Access Compliance Report Public Rights-of-Way (Curb Ramps)

Main Street: SHADEL_DR Cross Street: MAUVE_DR Location: SE

ADA ID: RPAT211025095213 Ramp Type: Type 3 - Combination 1 Initial Pass/Fail: Fail Overall Compliance: No Severity Score: 5

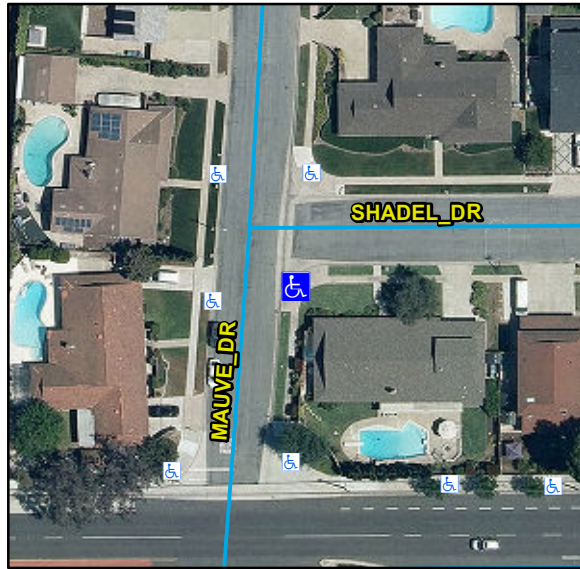
R304.2.2, R204.3, R304.5.1, R304.5.3, STD 1115

Remove & Replace Curb Ramp With Two New Directional Ramps or Equivalent.
